City of Albuquerque

RE: Jeannedale Drive Office Building Drainage Report Dated August, 1981
(File No. H-18-D16)

DRAINAGE REPORT COMMENTS

**JEANNEDALE DRIVE
OFFICE BUILDING
DRAINAGE REPORT**

FIGURE 1
PRIVATE GRATE INLETS

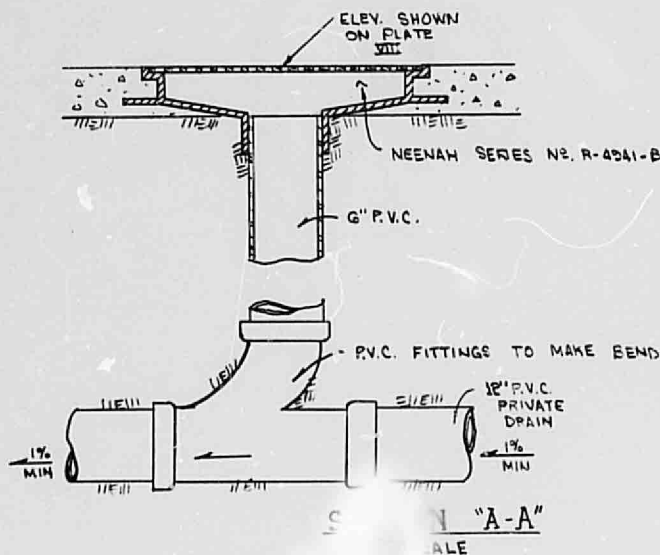
5) PROVIDE THE HYDRAULIC GRADE LINE WITH THE SUPPORTING CALCULATIONS FOR THE PROPOSED 18" S.D. CONNECTION. ALSO, YOUR INLET CAPACITIES FOR THE SINGLE "C" SHOULD TAKE INTO ACCOUNT A CLOGGING

5. Hydraulic grade line calculations will be provided with final design plans and information required by special Order No. 19. The single "C" catch basin specification shall be revised to specify a double "C" catch basin to provide a clogging factor of safety of 2.0.
